Reference: 3146/16

Site: Land at Orchard Way
Churfh Road Coddenham

1	Application Number	3146/16 Land at Orchard Way, School Lane, Coddendam, IP6 9PS	
2	Date of Response	25/10/2016	
3	Responding Officer	Name:	Rebecca Styles
		Job Title:	Heritage Officer
		Responding on behalf of...	Heritage
4	Summary and Recommendation (please delete those N/A) Note: This section must be completed before the response is sent. The recommendation should be based on the information submitted with the application.	1. The Heritage Team considers that the proposal would cause <ul style="list-style-type: none"> No harm to a designated heritage asset because the revised scheme with an increased plot size and increased distance of the proposed dwelling to be set back from the highway, as well as the removal of suburban, incongruous materials from the design have omitted the harm of the proposal to the Coddendam Conservation Area. 2. The Heritage Team recommends conditions as per section 7.

PROPOSAL: **Erection of a detached dwelling, formation of parking area and vehicular access**

PROPOSED SITE PLAN. 1:200 AT A3

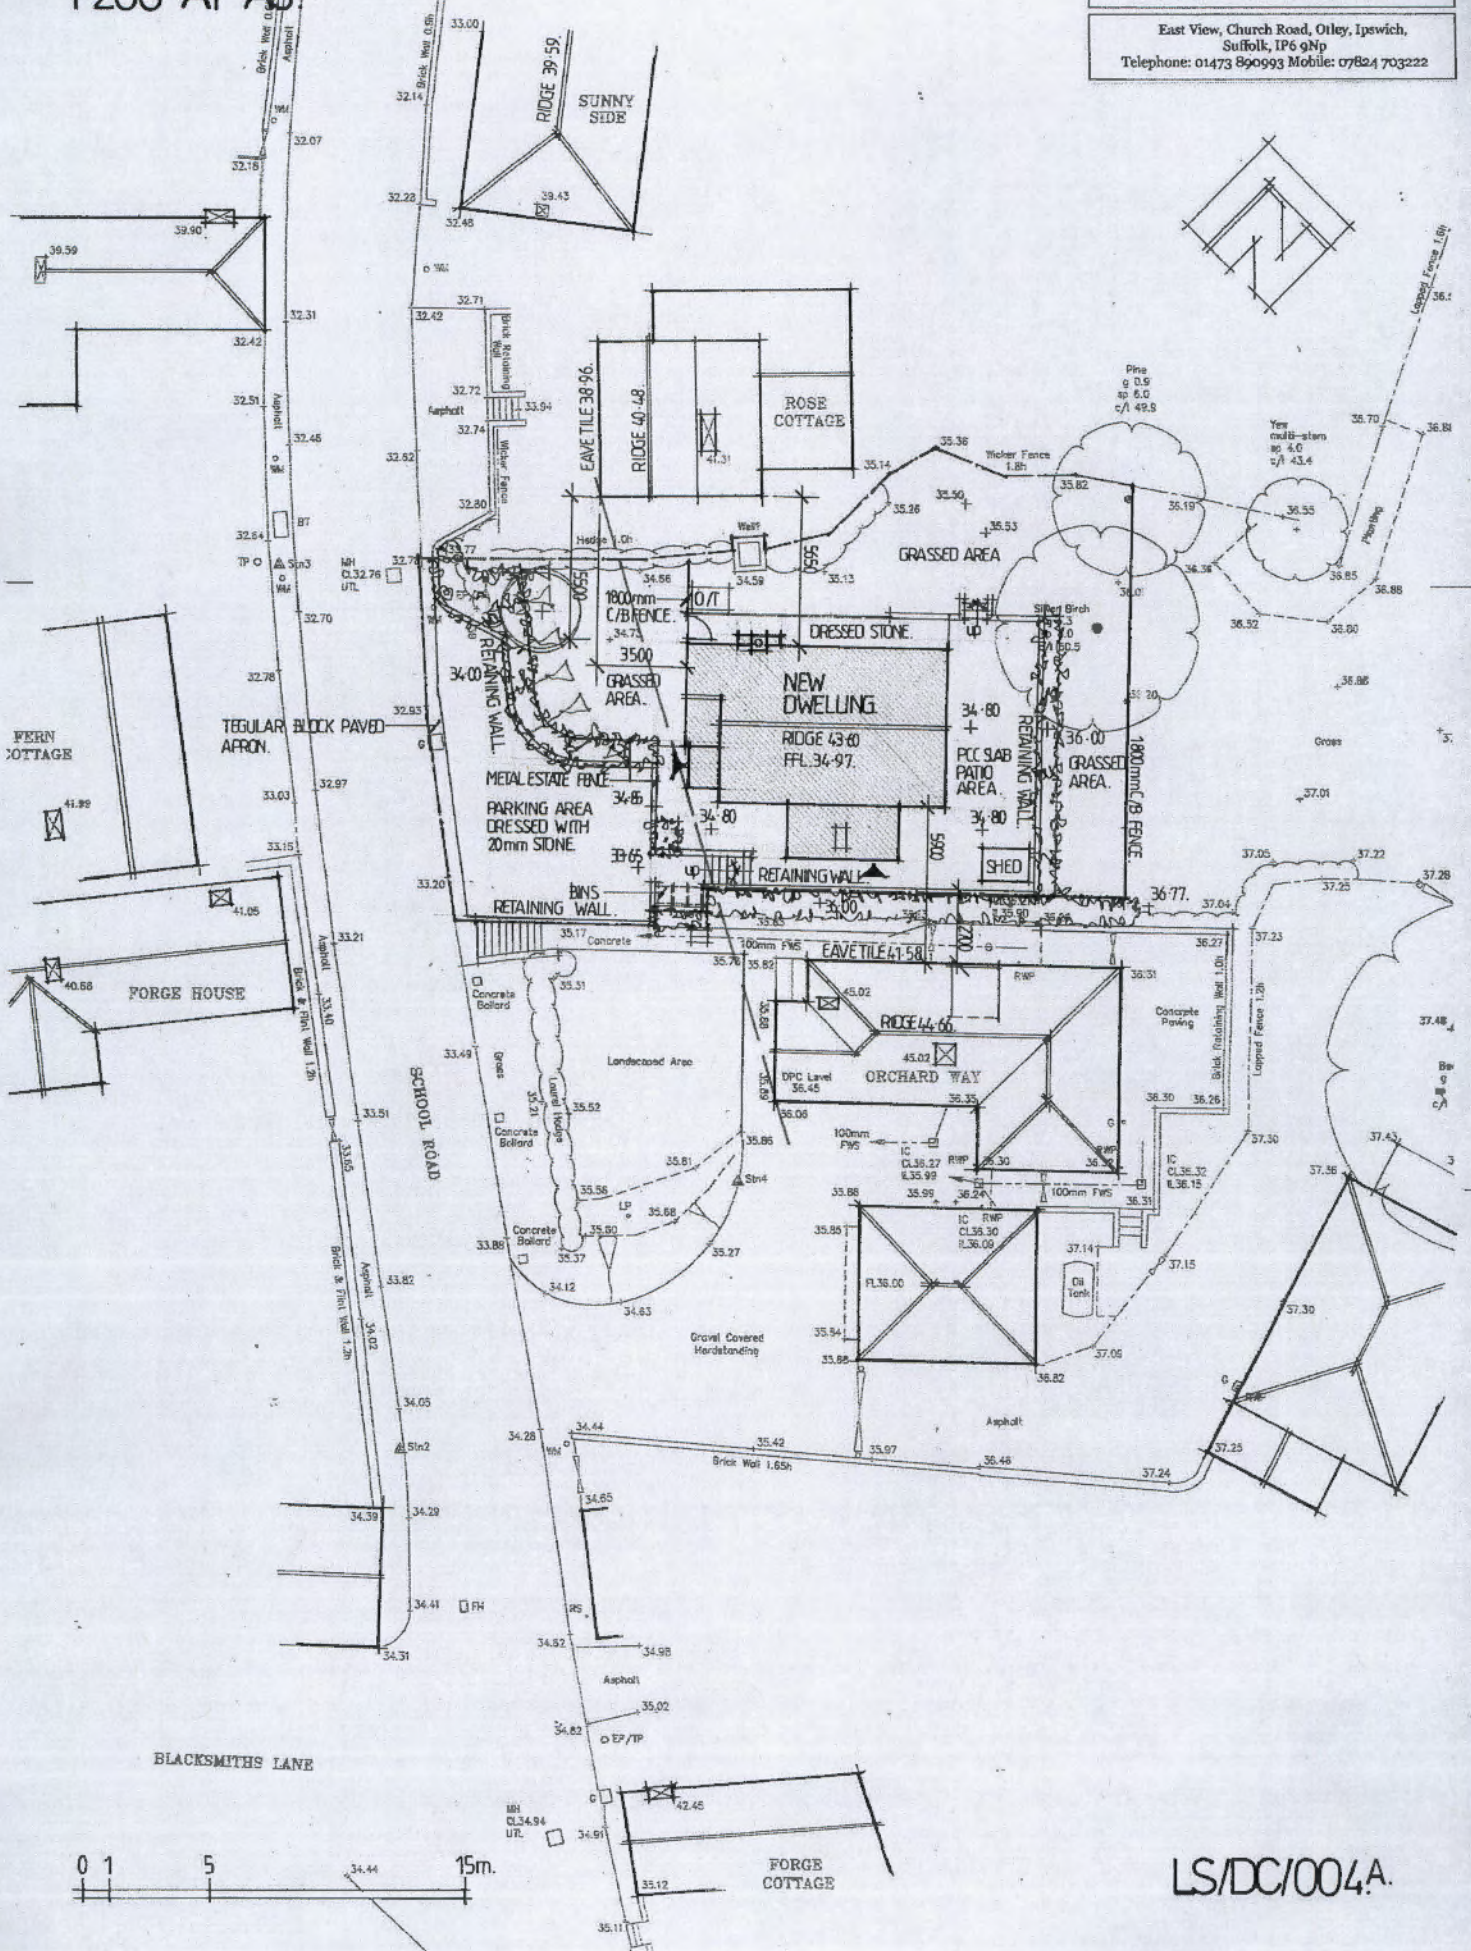
- Cladding to be stained black
- Drawings of railings to be agreed prior to commencement of development.
- Manufacture details and specification of rooflight to be submitted and agreed by LPA prior to commencement of development.
- Elevations of shed shown on drawing LS/DC/004A to be submitted and agreed prior to commencement of development.
- Render mix and component ratio to be agreed prior to commencement of development.
- Colour of painted render to be agreed prior to commencement of development.

PROPOSED ELEVATIONS.
1:100 AT A3.

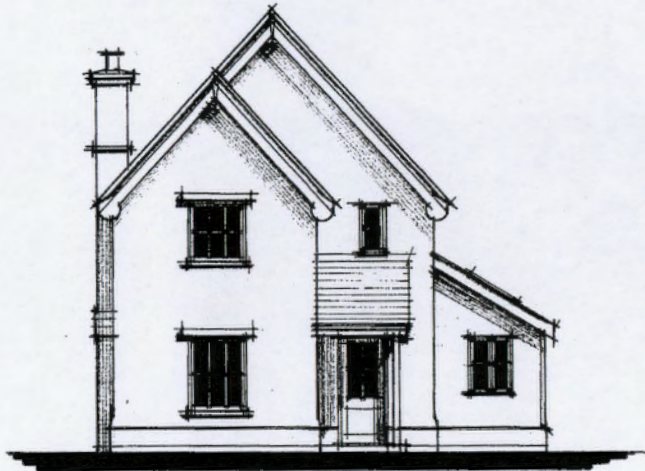
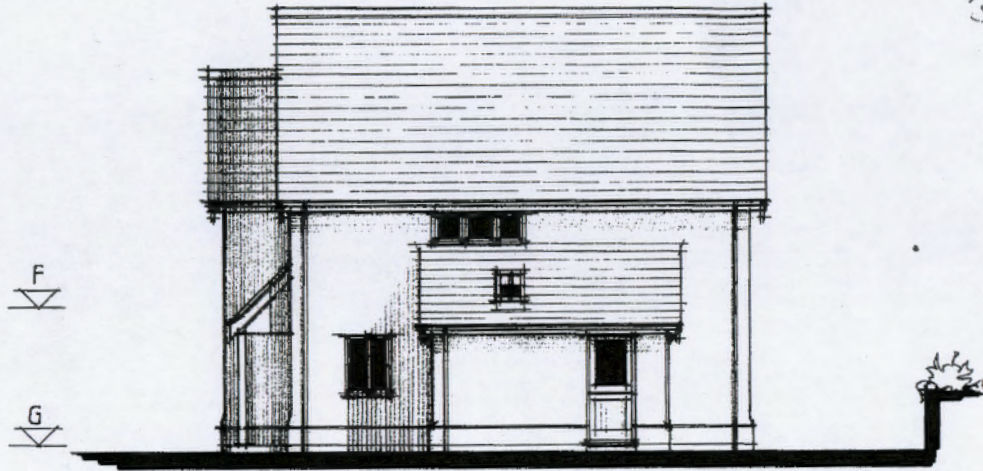
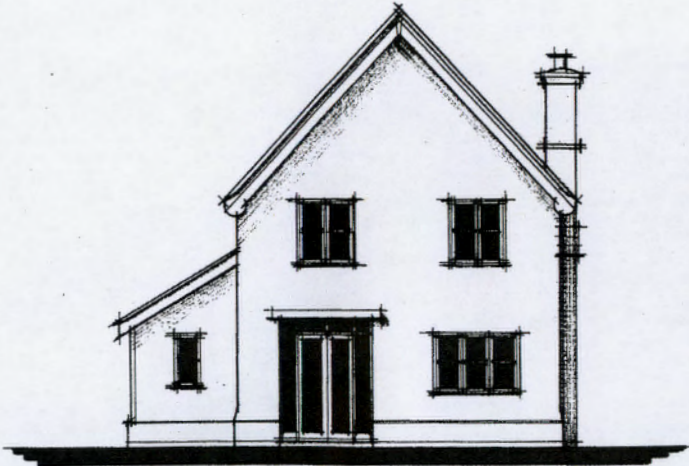
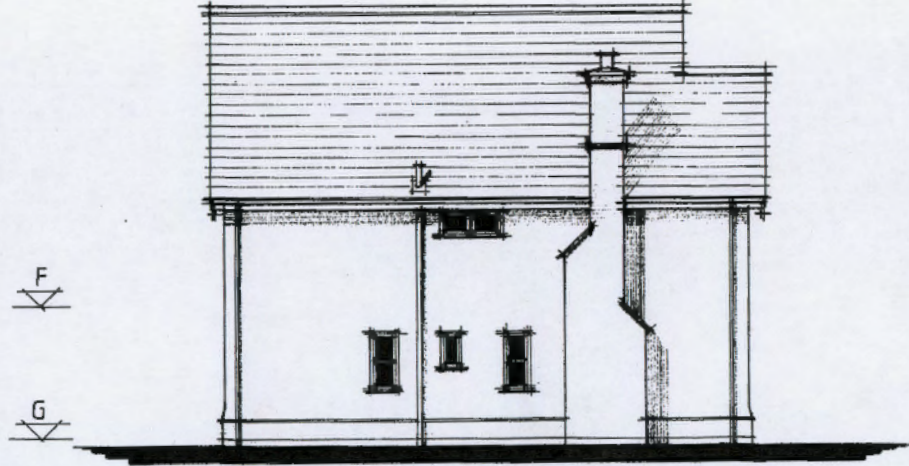
<p>on School Road upon the northern approach into Coddendam Conservation Area.</p> <p>The Heritage team does have a number of concerns over the present proposal.</p> <p>The positioning of the dwelling is in line with the principle elevation of Rose Cottage. Due to the elevated position of the east side of School Road, the dwellinghouse would be particularly prominent in its proposed location. The size of the proposed dwellinghouse would have a contrived appearance due to the small size of the application site compared to the large scale of the proposed dwelling. The Heritage team would prefer to see the principle elevation of the proposed dwelling more in line with the principle elevation of Orchard Way, further back from the highway. This will reduce the impact of the development on the street scene, and if the scale of the dwellinghouse is reduced, this would decrease the harm caused by the proposed development in the Conservation Area by creating a less contrived, more considered development.</p> <p>The proposed surface treatment for the parking area is block paving. The Heritage team would be more supportive of an application which used a less 'urban' surface treatment, which would cause less harm to the Coddendam Conservation Area through using materials more akin to a rural village setting.</p> <p>11 solar panels are proposed to be installed on the roof of the south elevation. The number and position of solar panels proposed would harm the setting of the Coddendam Conservation Area due to the modern and incongruous materials found in solar PV equipment. A reduced amount of solar panels and repositioning to create a more simple arrangement would reduce the harm of the solar panels to the Conservation Area. Perhaps other carbon reducing energy systems could be considered which would have less impact upon the Conservation Area.</p> <p>This application does not enhance the significance or character of the conservation area due to the position and scale of the development proposed, inappropriate surface materials and large amount of incongruous solar PV equipment on the southern roof slope. The Heritage team feels unable to support this application and considers it to be contrary to national and local policies – NPPF 137, MSDC Local Plan HB8.</p>

Information Required (if holding objection) If concerns are raised, can they be overcome with changes? Please ensure any requests are proportionate	less visual impact upon the Conservation Area. <ul style="list-style-type: none">- Revision of surface treatment for parking area of a less 'urban' design.- Repositioning/resizing of proposed dwelling to be more in line with the principle elevation of Orchard Way and to reduce the cramped and contrived effect of the proposal compared to adjacent, generously sized plots.
7	Recommended conditions

5	Discussion Please outline the reasons/rationale behind how you have formed the recommendation. Please refer to any guidance, policy or material considerations that have informed your recommendation.	<p>This consultation response refers to revised drawings, references LS/DC/001A, LS/DC/002A, LS/DC/003, LS/DC/004A, LS/DC/005A, LS/DC/006A, LS/DC/007A LS/DC/008A, LS/DC/MA/A regarding the proposal to erect a two storey detached dwelling within the Coddendam Conservation Area.</p> <p>The original concerns of the Heritage team considered the harm of to the Coddendam Conservation Area due to the position and scale of the development proposed, particularly as the eastern side of School Lane is higher than the west, whilst the small plot size gave the appearance of the dwelling appearing cramped and contrived; the inappropriate use of suburban surface materials and large amount of incongruous solar PV equipment on the southern roof slope were modern, suburban materials inappropriate to the rural village character of the Conservation Area. It was felt that the original proposal would cause less than substantial harm to the character of the Coddendam Conservation Area.</p> <p>These revised drawings have sought to address the original concerns of the Heritage team by increasing the size of the plot, moving back the principle elevation of the proposed dwellinghouse, revising the surface treatment and omitting the solar PV equipment from the southern roof slope. The design of the proposed lean to has been modified, the front bay window has been omitted, and the external facing of the dwelling is now proposed to be render instead of soft red brick.</p> <p>The increase in plot size and repositioning of the proposed dwelling would set the principle elevation of the</p>

<p>dwelling back by a further 3.5 metres (9.3 metres in total from the highway) provides the dwelling a more generous plot which no longer has a cramped and contrived appearance. The modifications to the design of the proposed dwellinghouse by reducing the scale of the lean to and removing the bay window from the proposal give the dwelling a more modest appearance. This more simplistic design, along with the increased plot size and the greater extent of the dwelling being set back from the highway would reduce the impact of the proposed dwelling on the Conservation Area as the drawings no longer present an overcrowded or confined appearance of the proposed dwelling.</p> <p>The removal of the solar PV and permeable block paving are welcome alterations to the scheme, removing incongruous, suburban materials from the proposal, and the dwelling would now provide a more traditional appearance which would be more in keeping with the Conservation Area.</p> <p>The revised facing material of painted render rather than soft red bricks is a suitable material which is representative of traditional materials used within the Conservation Area, and the Heritage team supports this amendment to the proposal.</p> <p>The proposal will have an effect on the Coddendam Conservation Area, in the sense that there would be a new dwelling where there is presently domestic garden land, however it is not considered that this effect will be a harmful one with regard to the character of the Conservation Area. The Heritage team therefore removes its objection to the scheme, subject to the following conditions.</p>
